7.6 All Other Instrumentation Systems Required for Safety

The information in this section of the reference ABWR DCD, including all subsections, tables, and figures, is incorporated by reference with the following departures and supplements.

Figure 7.6-4a Basic Configuration of a Typical Neutron Monitoring System Division

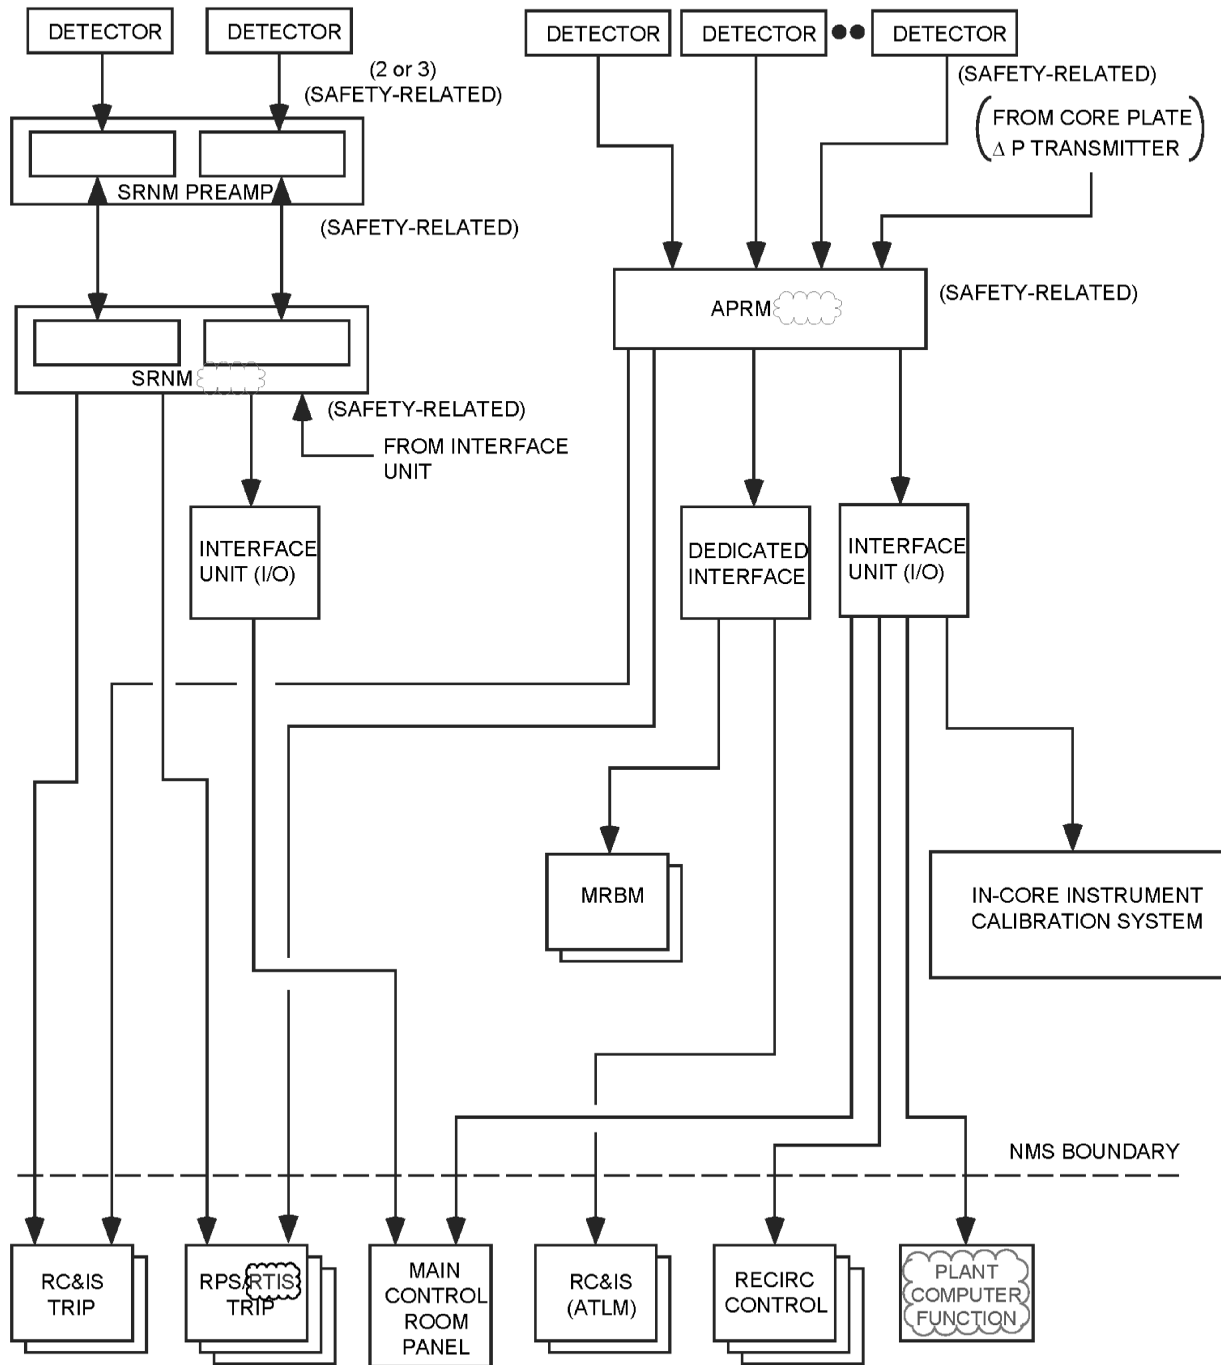
STD DEP T1 3.4-1 (Table 7.6-5 and Figures 7.6-1, 7.6-2, 7.6-4a)

Figure 7.6-9 Instrumentation Location Definition for the Suppression Pool Temperature Monitoring System

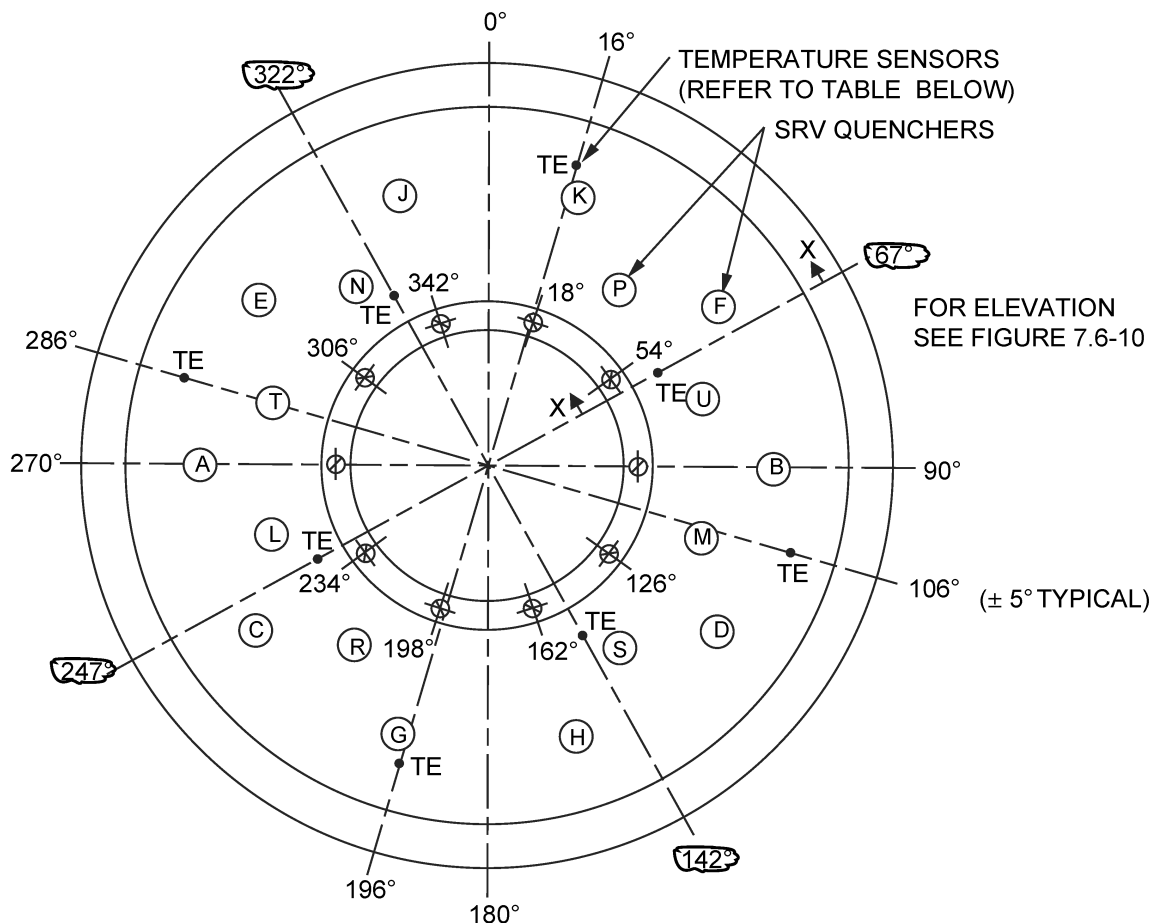
STD DEP 7.6-3 (Figures 7.6-9, 7.6-11)

STD DEP 7.6-3

The SPTM System configuration is shown in Figures 7.6-9 and 7.6-10. There are eight temperature circumferential sensor locations (Figure 7.6-9), which are chosen based upon the following considerations:

Figure 7.6-14 OPRM Logic

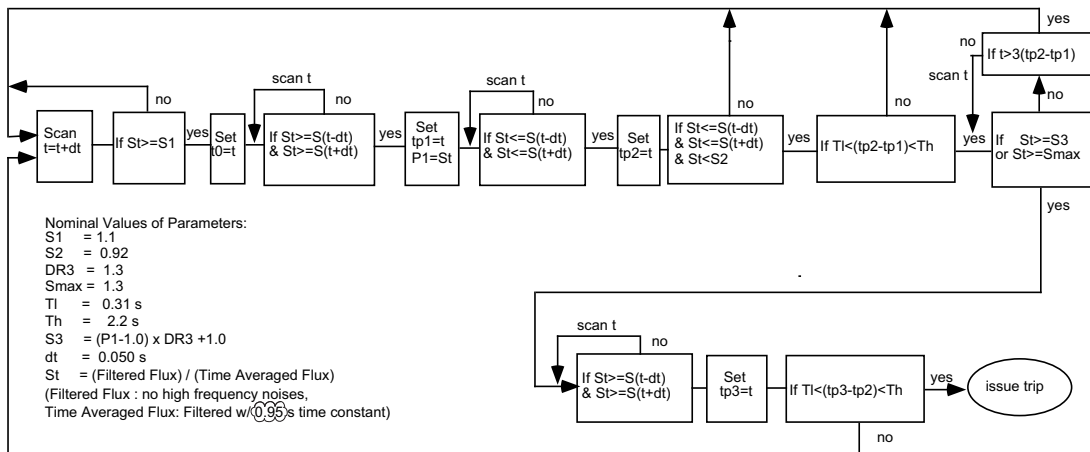
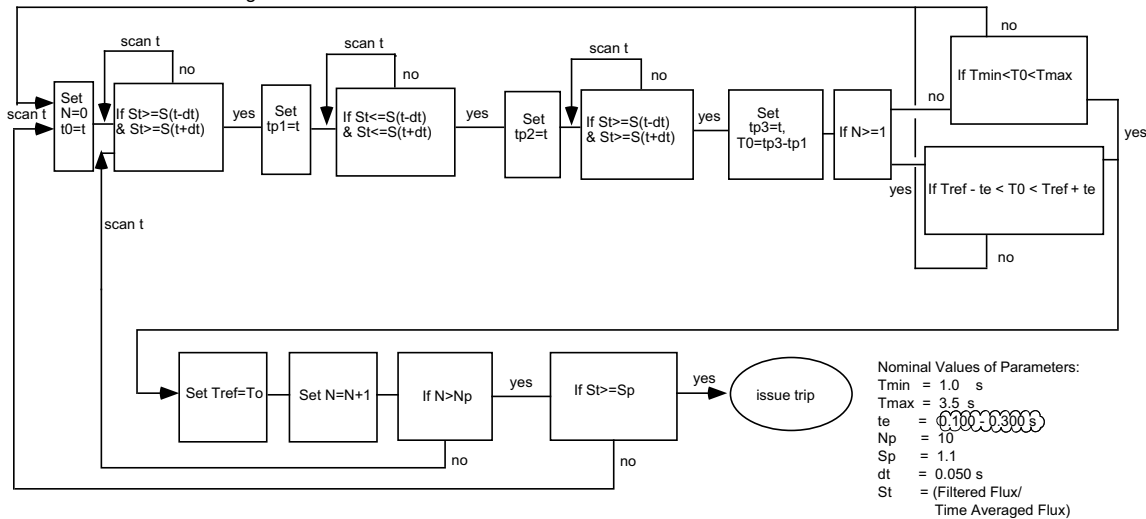
STD DEP 7.6-1 (Table 7.6-2 and Figures 7.6-2, 7.6-14)

For the OPRM trip function, the response signal of any one OPRM cell that satisfies the conditions and criteria of the trip algorithm will cause a trip of the associated OPRM channel. Figure 7.6-14 illustrates the trip algorithm logic. ~~The OPRM trip function does not have its own inoperative trip for insufficient number of total LPRM inputs in the channel. It follows the APRM's inoperative trip of insufficient number of LPRMs.~~ The OPRM function has its own inoperative trip when the channel has less than the required minimum operable cells, when there is an OPRM self-diagnostic fault, when the APRM instrument watchdog timer has timed out, or if there is a loss of power to the APRM instrument.

$T_{\min}=1$ s, $T_{\max}=3.5$ s, $\pm t_{\text{error}}=0.15$ s **[0.100 - 0.300s]**, $N_P=10$.
 (For details see Figure 7.6-14).
